D1 Submission: Design Concerns.

Panels and Tables.

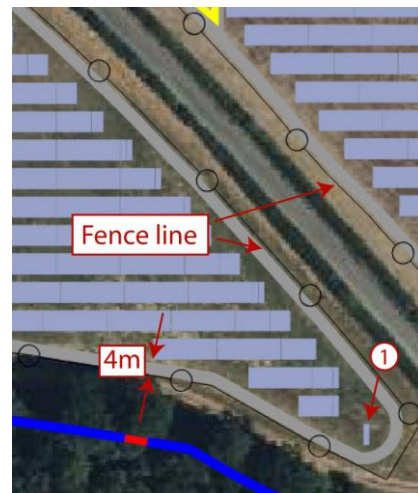
3) The north-south table gap is specified in Project Description as between 1.5m and 3.0m; the gaps measured on the Masterplan are 1.5m (panel:gap ratio 3:1).

This is considerably narrower than the 4.0m gap that one sees typically in the UK. At lower latitudes tight spacing might be acceptable, but up here at 52°N the sun never gets very high: tight spacing will result in excessive energy loss for much of the day due to self-shading (shadow from the adjacent row of panels to the south).

A solar farm in nearby Didcot uses a panel:gap ratio of less than 1:1. (51°38'08"N 1°21'13"W)

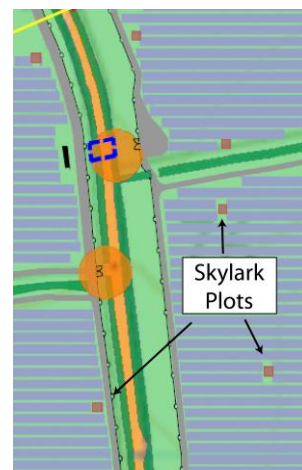
5) Longi supplies the LR5-72HGD at power ratings between 560W and 590W.

This should not be confused with a car manufacturer offering a range of engine options. Longi manufactures the LR5-72HGD; variation in manufacturing tolerance results in spectrum of performance rolling off the production line. Whilst PVDP should be applauded for committing to the premium product (like all other NSIP applications), this is not a credible scenario. We cannot rely on all the other solar farm constructors settling for the budget end variants.

For the purpose of planning, does it make more sense to calculate performance and CO₂ emission data based on a mid-range variant, such as 575W?
